**SHEARON HARRIS NUCLEAR POWER PLANT, UNIT NO. 1  
DOCKET NO. 50-400/LICENSE NO. NPF-63  
SUPPLEMENT TO REQUEST FOR LICENSE AMENDMENT  
TO CREDIT SOLUBLE BORON FOR FUEL STORAGE POOLS**

This letter provides revised Attachments 3 and 4 due to inadvertently omitting unchanged text that had rolled onto another page and associated changes to the index. For clarity, these attachments replace Attachments 3 and 4 of the original letter in their entirety.

**SHEARON HARRIS NUCLEAR POWER PLANT, UNIT NO. 1  
DOCKET NO. 50-400/LICENSE NO. NPF-63  
SUPPLEMENT TO REQUEST FOR LICENSE AMENDMENT  
PROPOSED TECHNICAL SPECIFICATIONS (TS) CHANGES**

## Technical Specification Insert B:

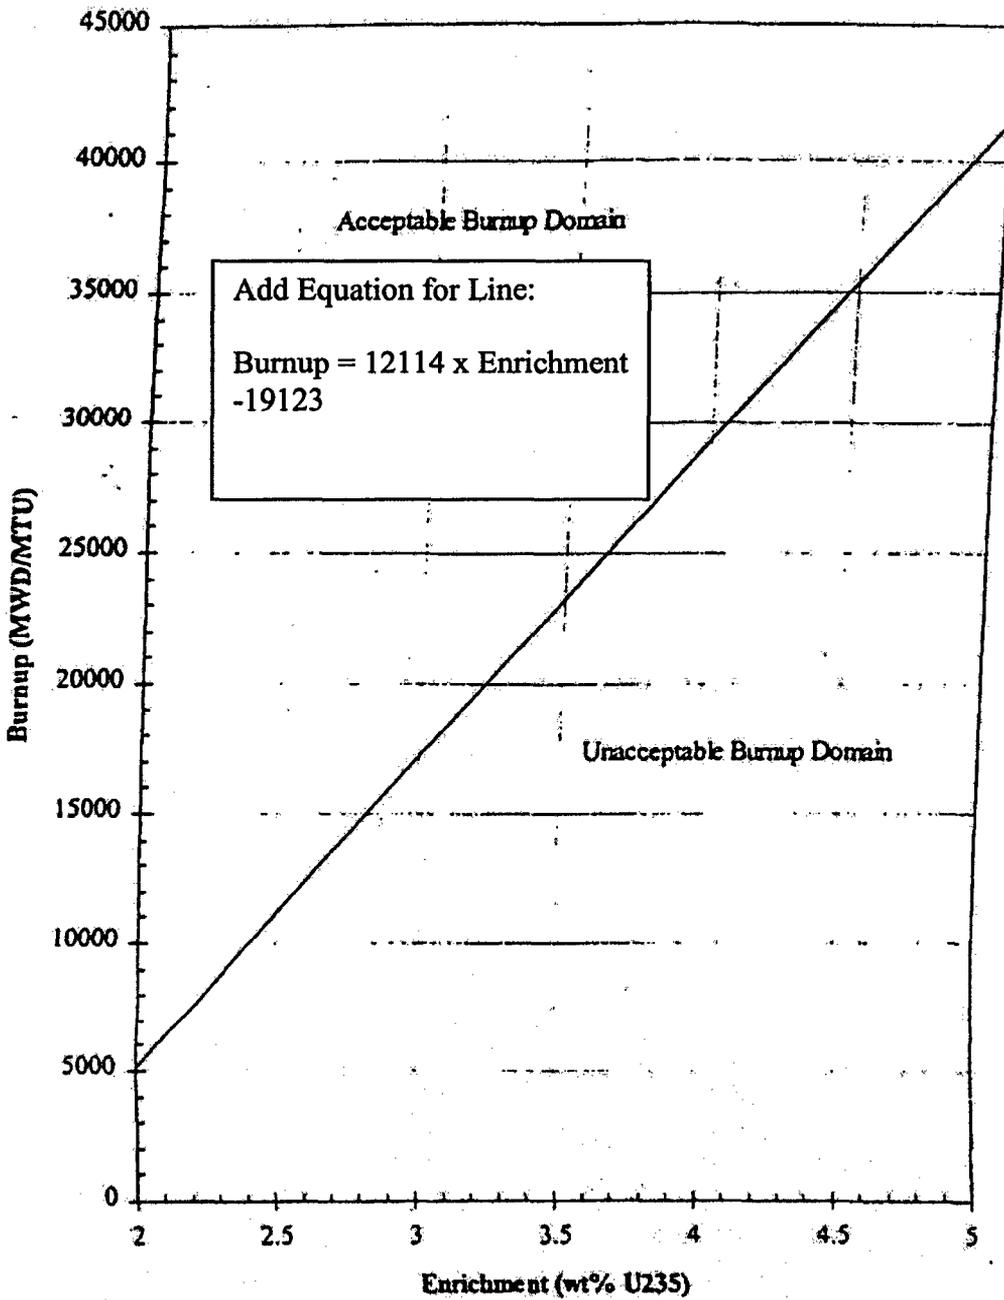
### 4. PWR and BWR storage racks in Pools "C" and "D"

- a.  $k_{\text{eff}} \leq 0.95$  with unborated water.

Figure 5.6-2  
Pools "A" and "B" BURNUP VERSUS ENRICHMENT FOR PWR FUEL

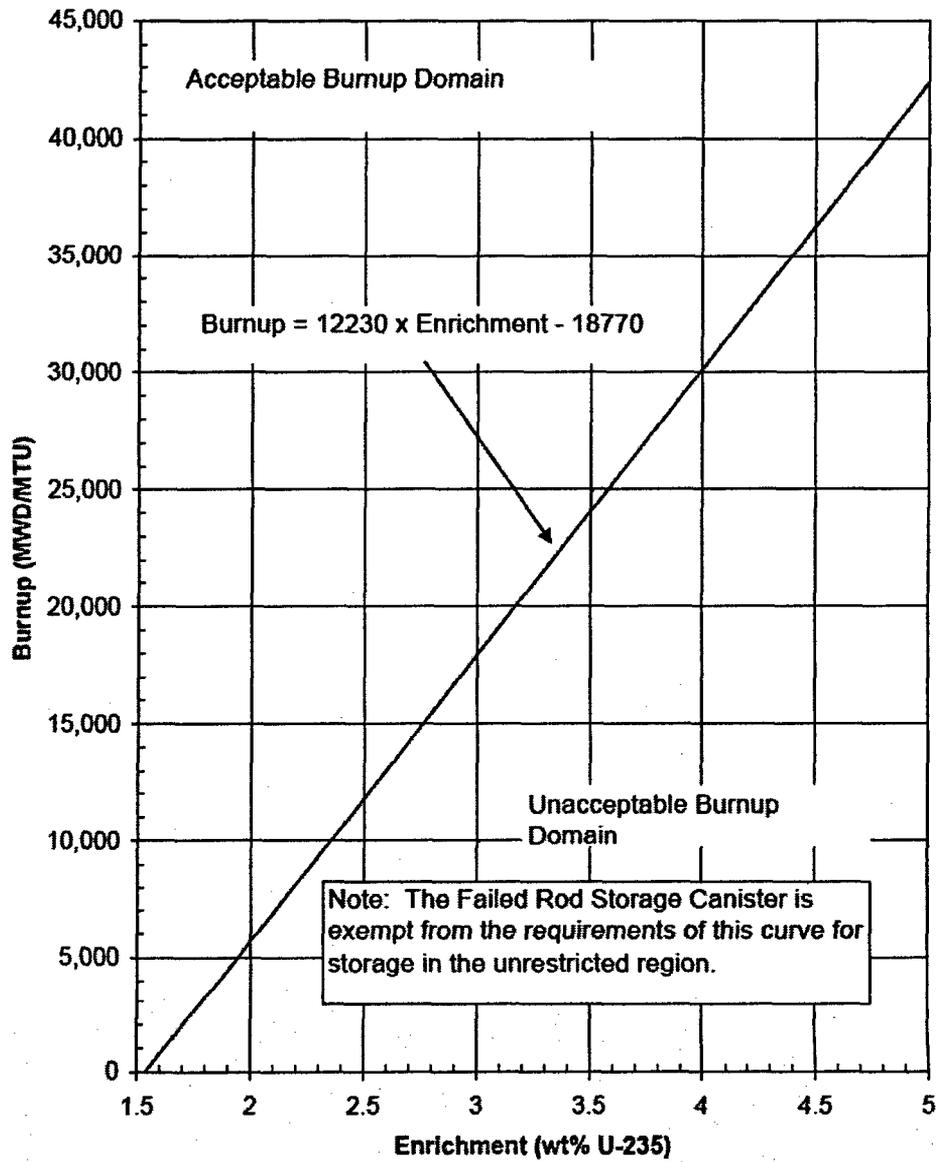
- c. A nominal 10.5 inch center-to-center distance between fuel assemblies.
  - d. Assemblies must be within the "acceptable range" of the burnup restrictions shown in Figure 5.6-2 prior to storage in unrestricted storage.

- c. A nominal 10.5 inch center-to-center distance between fuel assemblies.
  - d. Assemblies must be within the "acceptable range" of the burnup restrictions shown in Figure 5.6-2 prior to storage in unrestricted storage.

FIGURE 5.6-1  
POOLS "C" and "D" BURNUP VERSUS ENRICHMENT FOR PWR FUEL

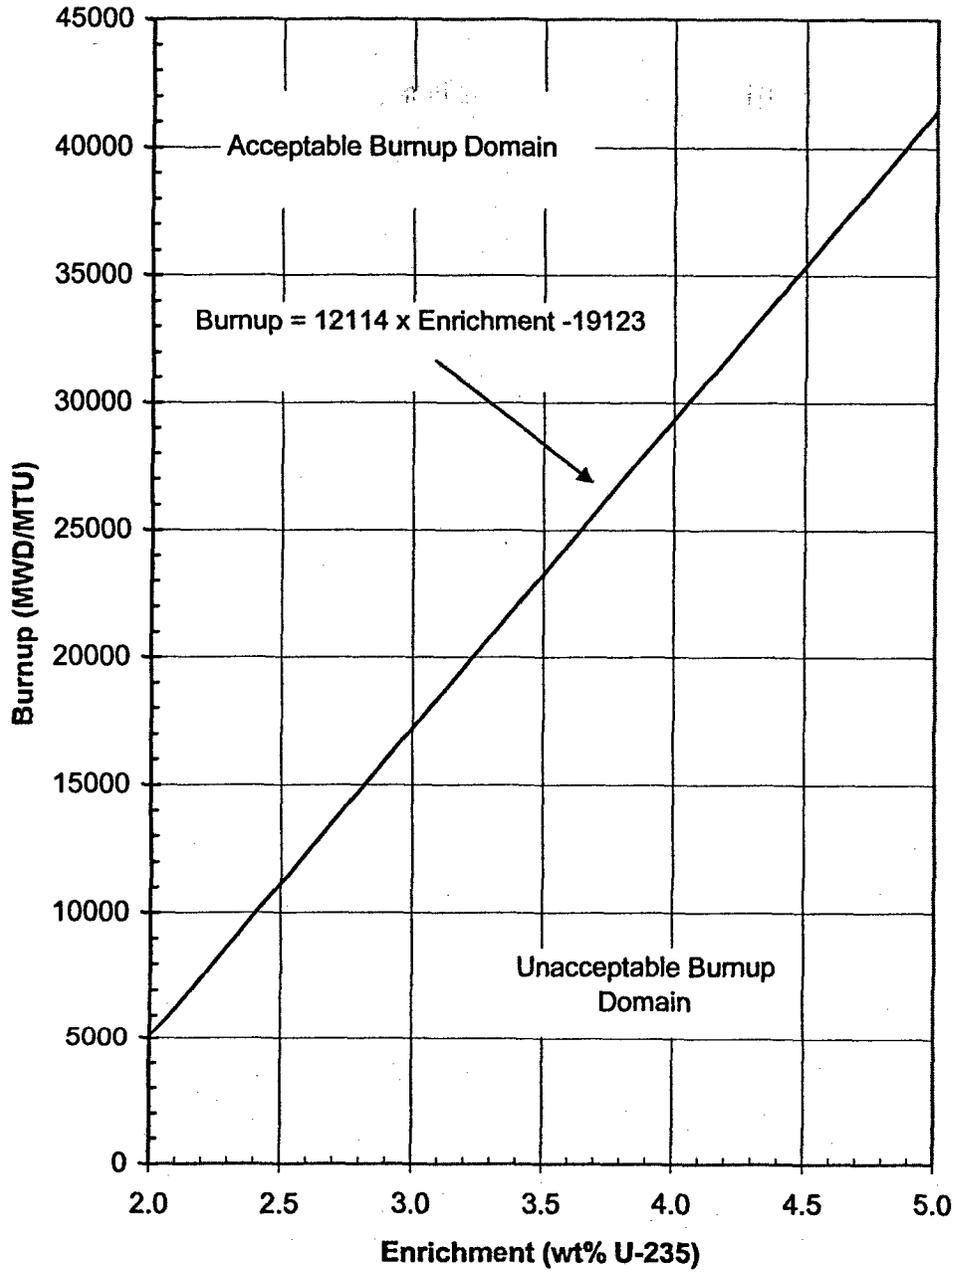
POOLS "C" AND "D"

FIGURE 5.6-1  
BURNUP VERSUS ENRICHMENT FOR PWR FUEL

New Technical Specification Figure

- c. The following restrictions are also imposed through administrative controls:
    1. PWR assemblies must be within the "acceptable range" of the burnup restrictions shown in Figure 5.6-1 prior to storage in pools "C" and "D".
